TITLE: **SPECIAL PERMIT NO. 1813, THE PRESERVE ON ANTELOPE CREEK COMMUNITY UNIT PLAN,** requested by Essex Corporation on behalf of Nebraska Nurseries, Inc., for 150 dwelling units and 180 dwelling units of retirement housing (both assisted and independent), on property generally located at the southwest corner of 80th Street and Pioneers Blvd.

LINCOLN CITY/LANCASTER COUNTY PLANNING STAFF REPORT

P.A.S.#: Preliminary Plat #99027 **Date:** December 5, 2000
Special Permit #1813
Use Permit #125
The Preserve on Antelope Creek
****As Revised by Planning Commission on January 10, 2001****

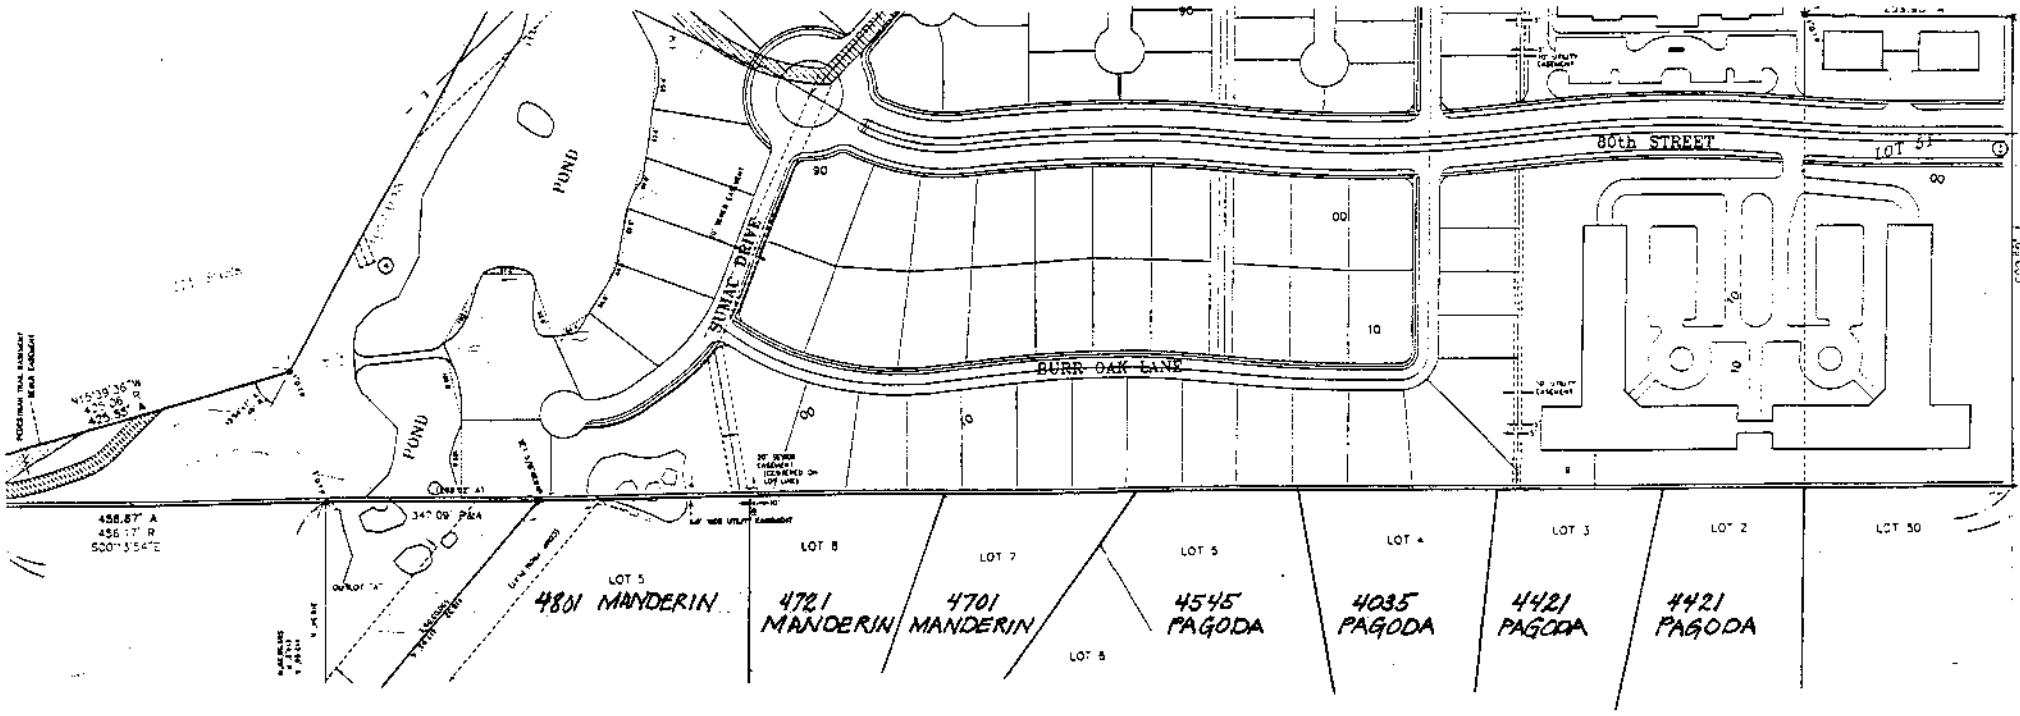
1. The Owner/Developer has redesigned the preliminary plat to provide for larger single family lots in lieu of smaller single family lots adjacent to our property. (See Exhibit A)

2. Trees will be added on our property as a landscape buffer to the new residential development. Tree species will be of our choice from available trees on the Owner/Developers site. The trees will be relocated by Owner/Developer at no cost to us. (See Exhibit A)

1. Trees will be added on our property as a landscape buffer to the new independent senior living area. Tree species will be of our choice from available trees on the Owner/Developers site. The trees will be relocated by Owner/Developer at no cost to us. (See Exhibit A)
